Soldier Creek Coal Company
HIDDEN VALLEY MINE

Re: Interim Program Regulations
Hidden Valley Mine
ACT/015/022

MEMORANDUM

SUBJECT: Soldier Creek Coal Company
Proposed Hidden Valley Mine
Emery County, Utah
ACT/015/022

Figure 1.
 pg. 2

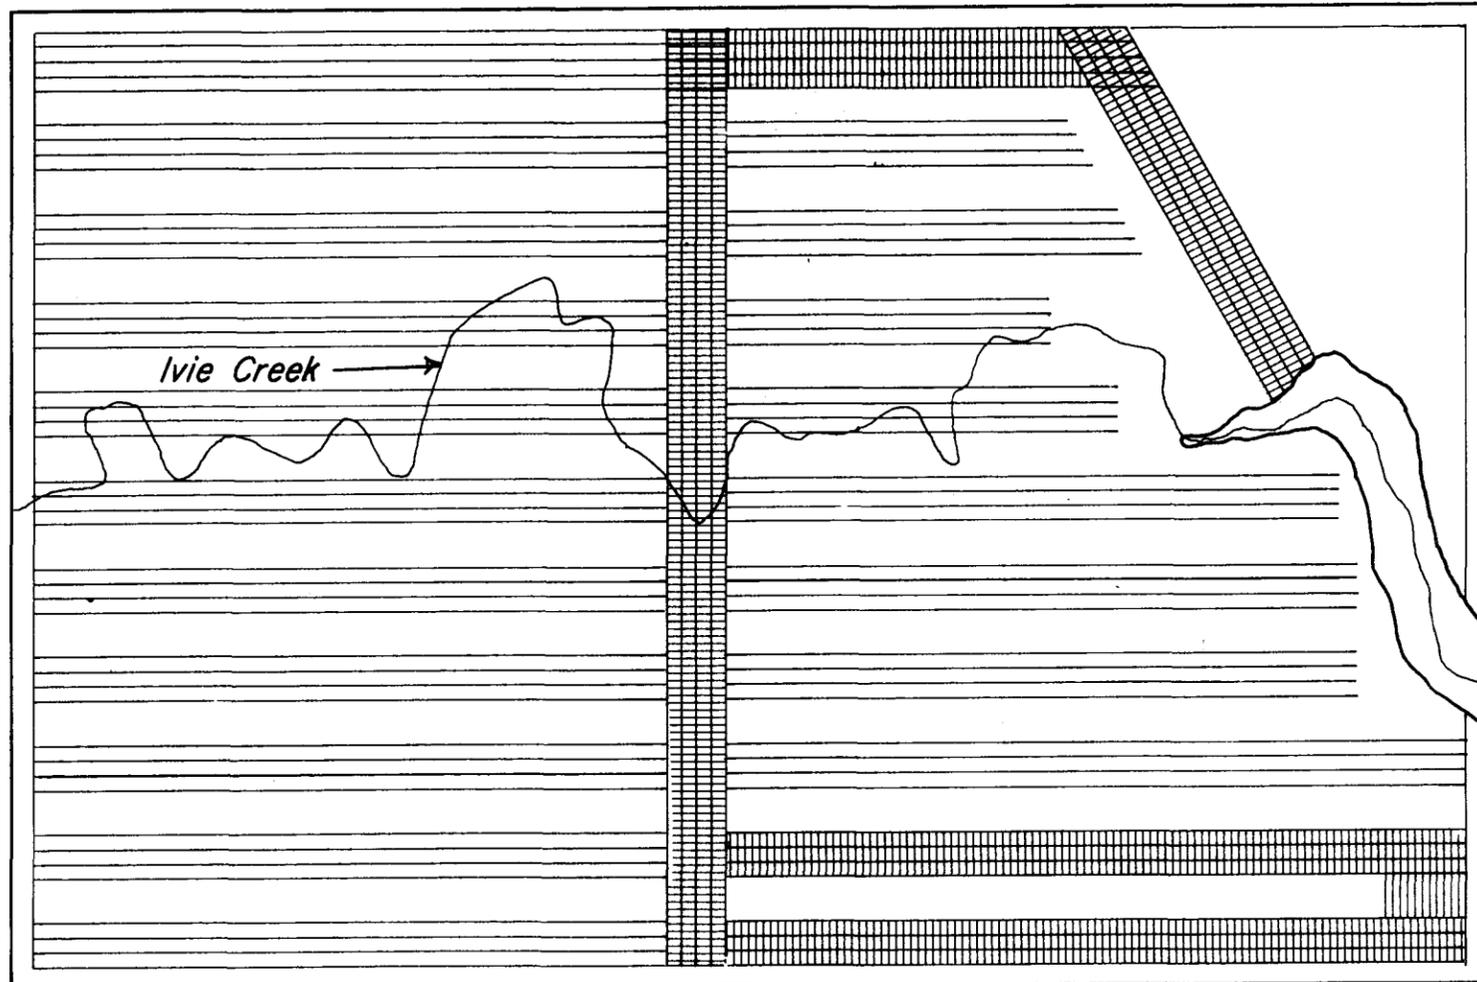
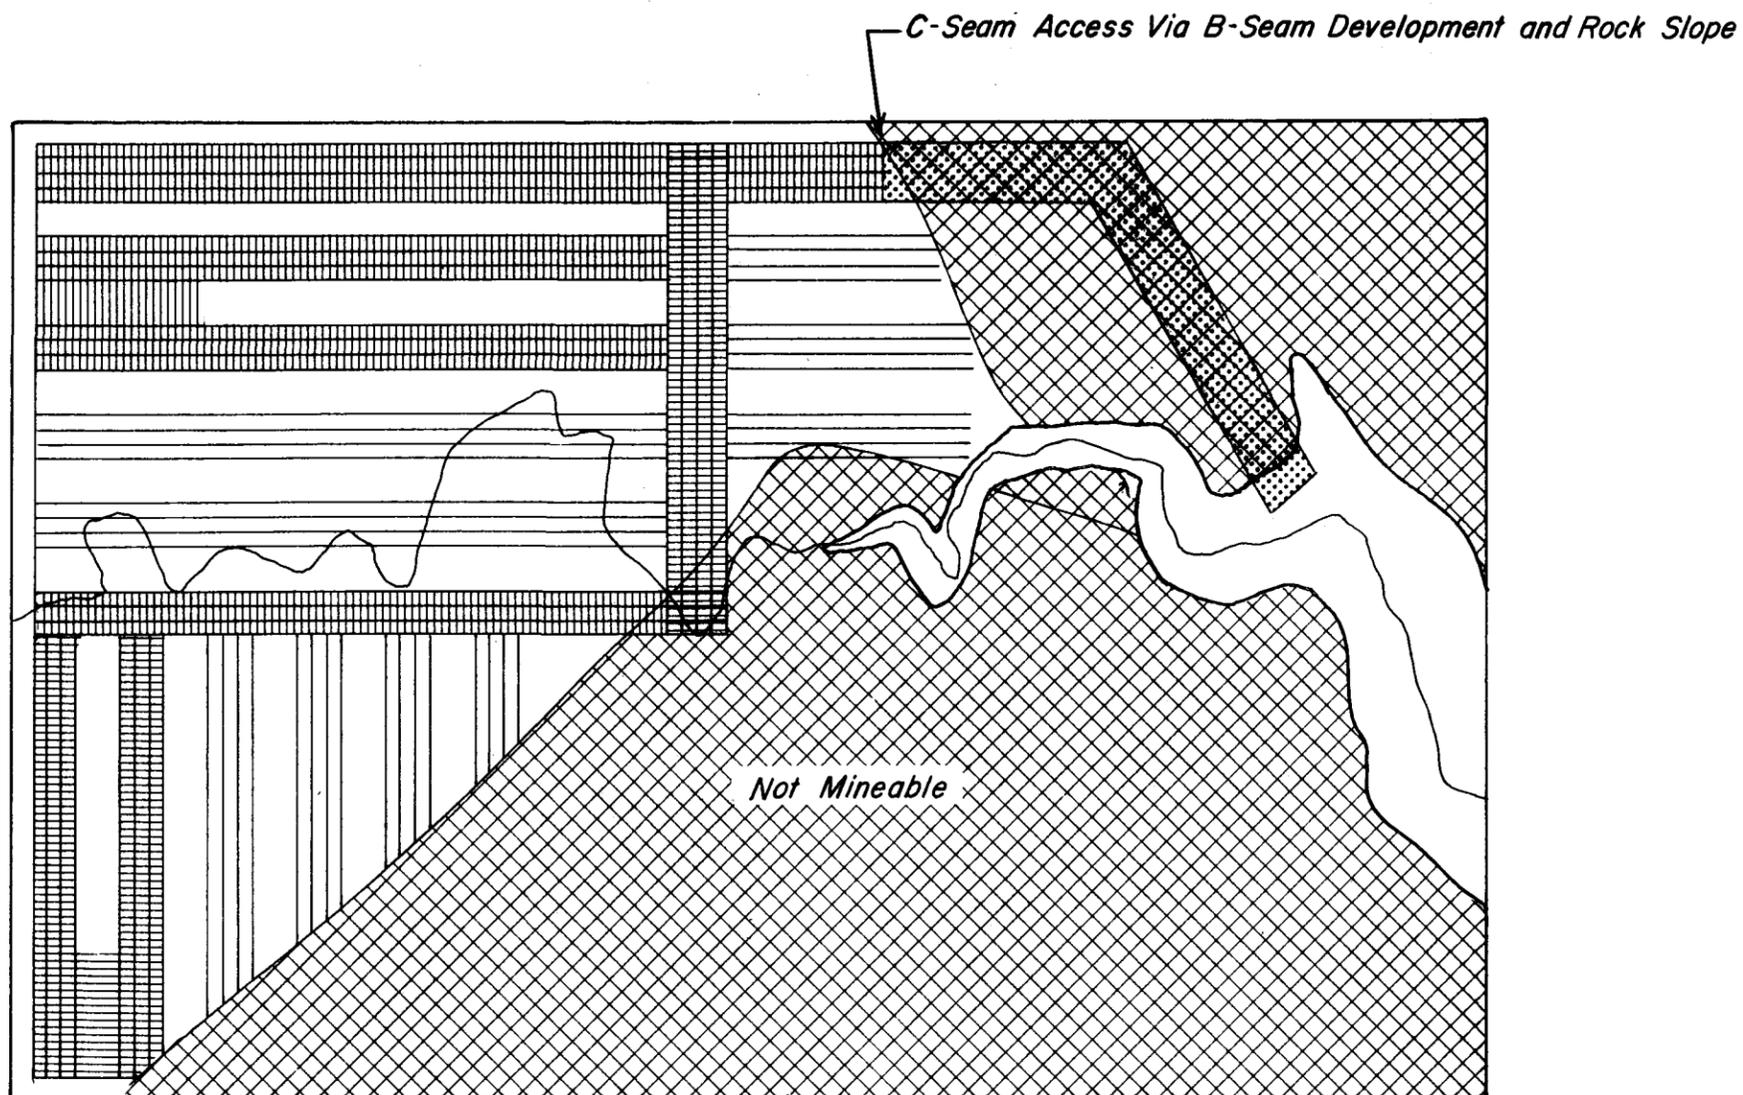
1. An amendment is needed stating which seam(s) will be mined and how mining development will progress, along with proposed time frames.

Three mineable seams exist at Hidden Valley Mine. They have been designated as the A, B, and C Seams in ascending order. Preliminary plans call for the systematic mining of all three seams. Multiple seam mining will be accomplished by the extraction of the upper seam preceding the lower seam.

The proposed mine layout and projected five-year development for the B and C Seams are shown in Figures 1 and 2 respectively. The proposed mine layout for the A Seam is identical to that of the B Seam.

Since the C Seam is mineable only on the western half of the property, initial development will begin in the B Seam. The C Seam will then become accessible via the B Seam development and a rock slope as indicated in Figure 2.

*--Soil Sample Location

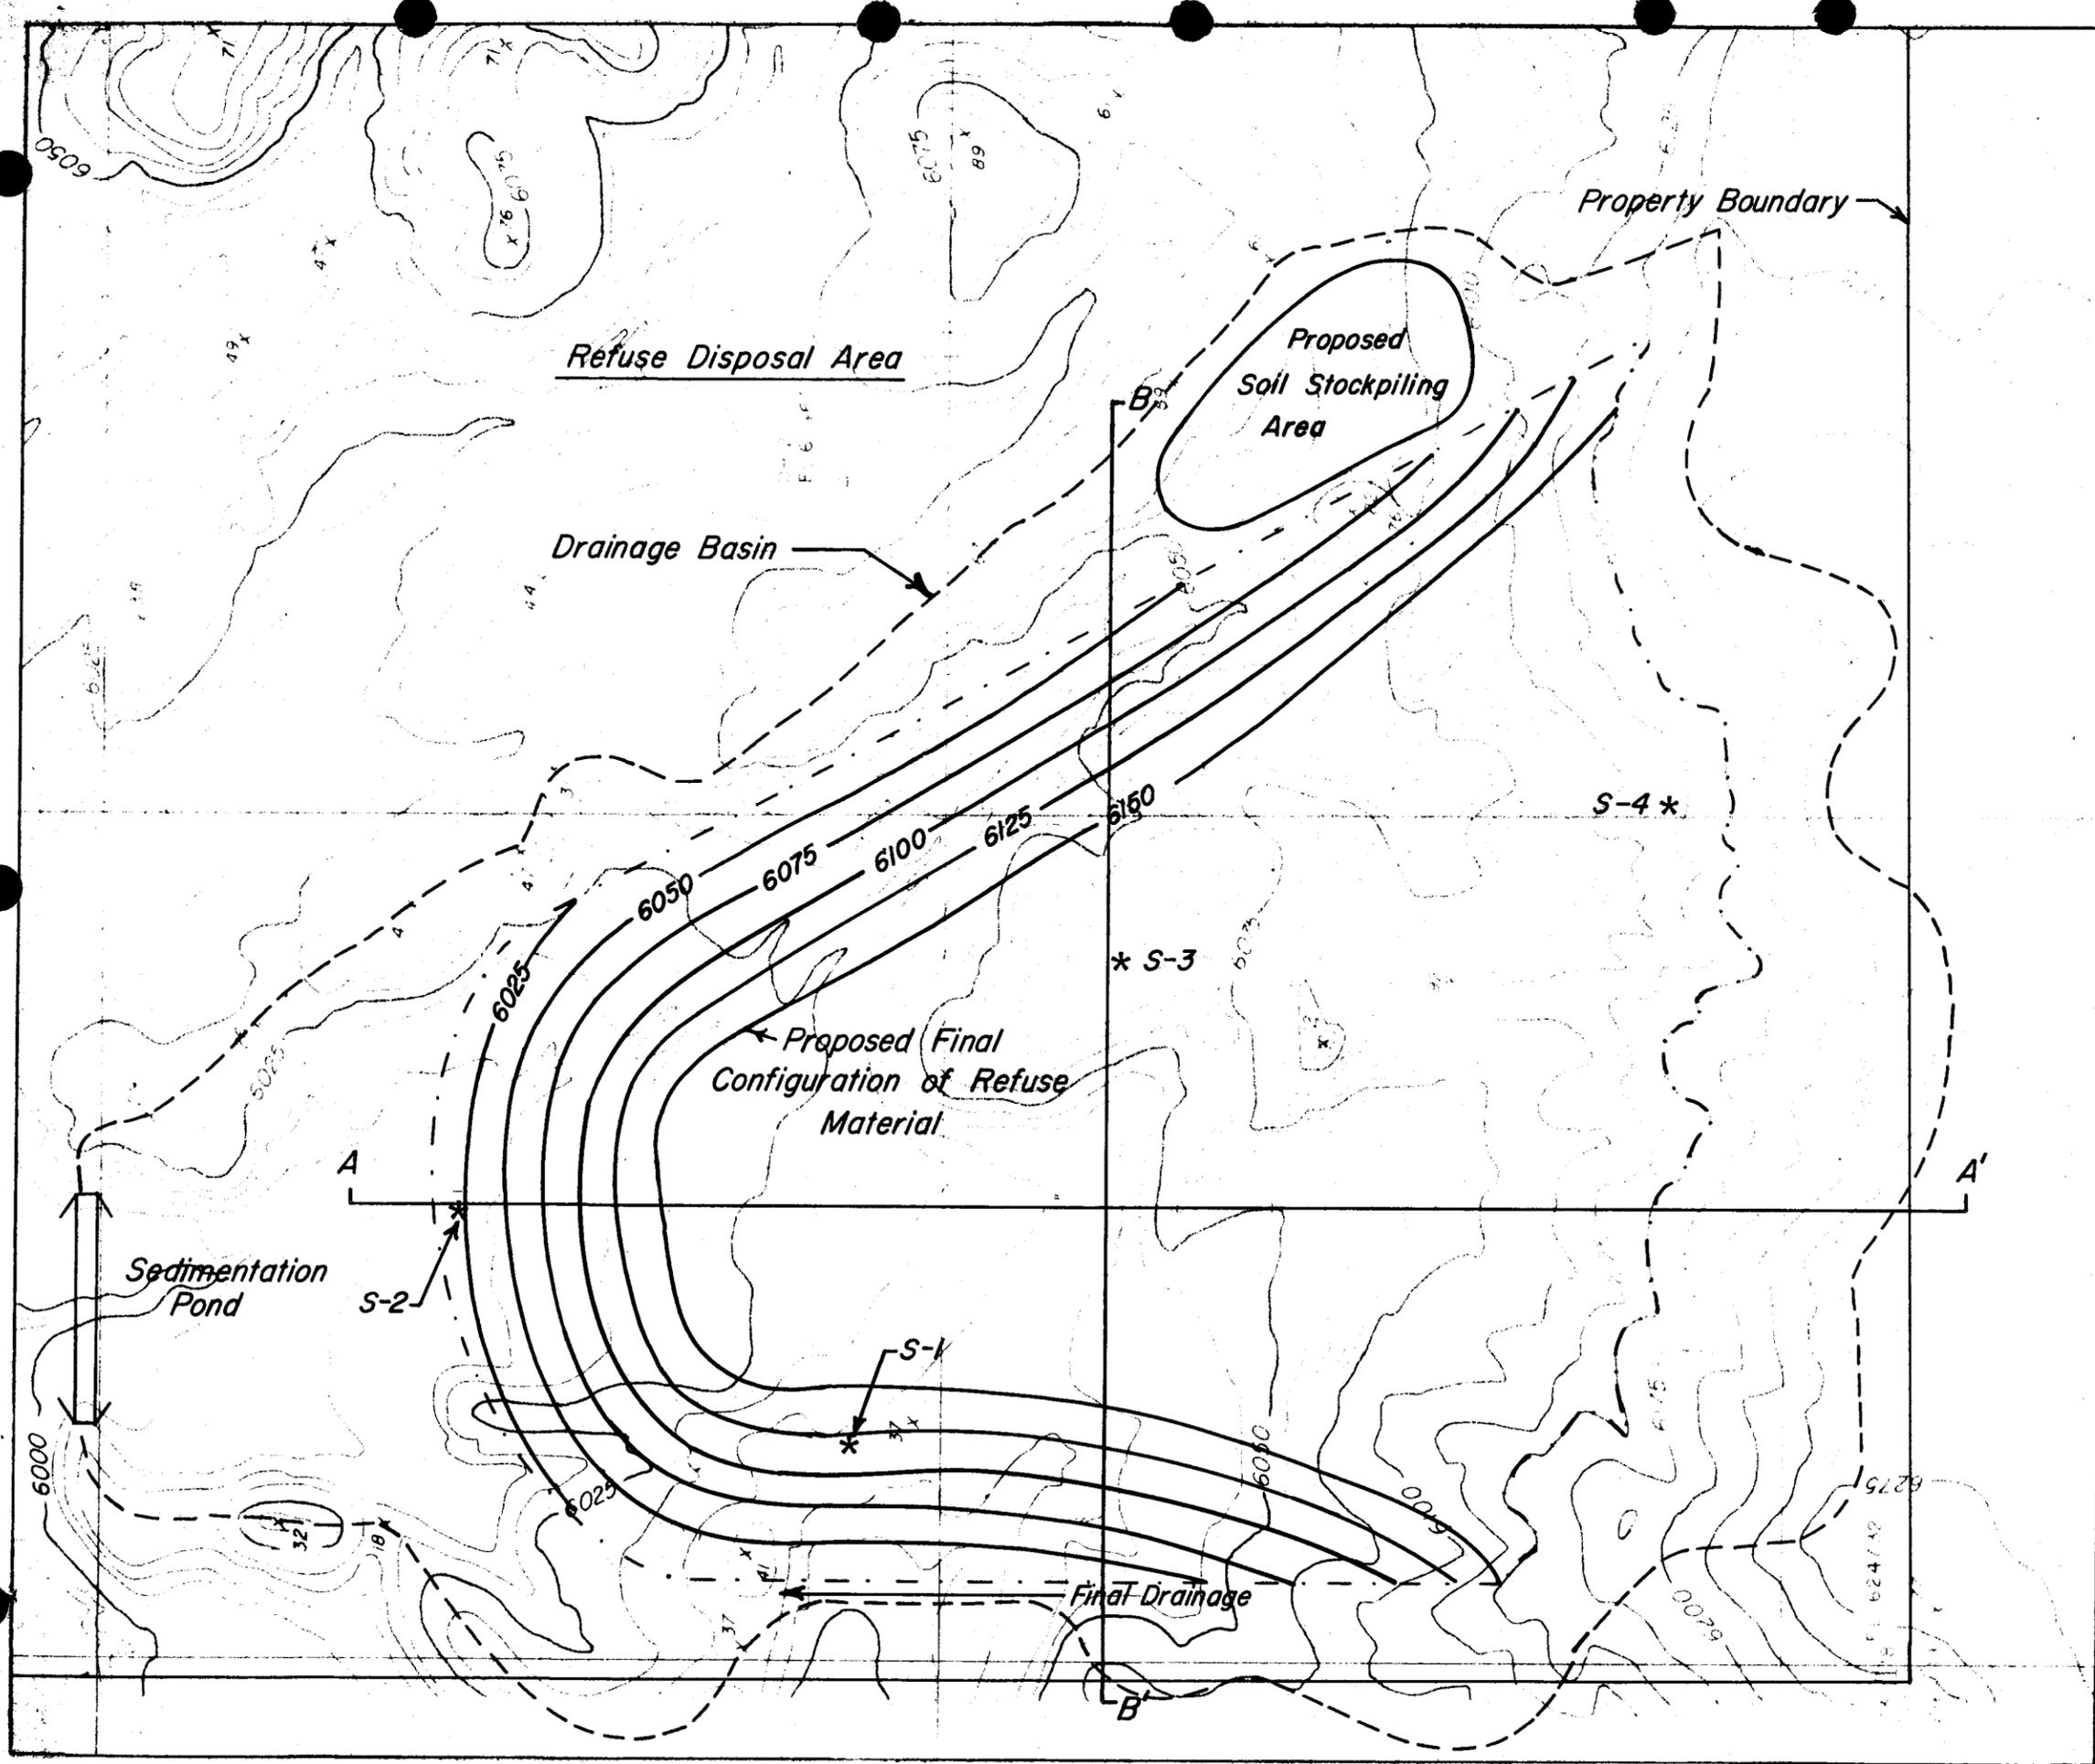
1. Pre-mining and post-mining profiles of the refuse disposal areas should be submitted.

2. The following applies not only to the refuse disposal area, but also to all of the disturbed areas. Unless it is demonstrated by the applicant that alternative topsoil and surficial material is available; the borrow area is included in the permit application; and insufficient topsoil and unconsolidated surface material is available on-site; the material must be removed, segregated, stockpiled and protected. Using the material for fill, or berms, etc. at the discretion of the operator can not be permitted. However, if it is demonstrated by the operator that the amount of topsoil and unconsolidated surficial material necessary for reclamation is stockpiled as required, the excess unconsolidated surficial material may possibly be utilized as proposed.

Several soil samples have been taken within the refuse disposal area as indicated in Figure 3. Analyses of these samples presented in Table 1, indicate that the soil revegetation potential is generally favorable. Lime and pH are normal with potassium being adequate in all profiles. The sodium adsorption ratio is basically low for all samples. Low phosphorus values and soluble salts, especially in subsoils, may create moderate problems. The accumulation of salts may affect sensitive plants in dry periods. However, it is believed that many species would not be seriously affected.

It is proposed that prior to initiating any development within the refuse disposal area, that a 6-inch layer of surface soil be removed, segregated, and designated as topsoil. This is in accordance to 30 CFR 817.22 (c). This amount will be removed to the extent possible using conventional equipment. Topsoil removed will be stockpiled and stabilized in a designated area until required for reclamation (see Figure 3).
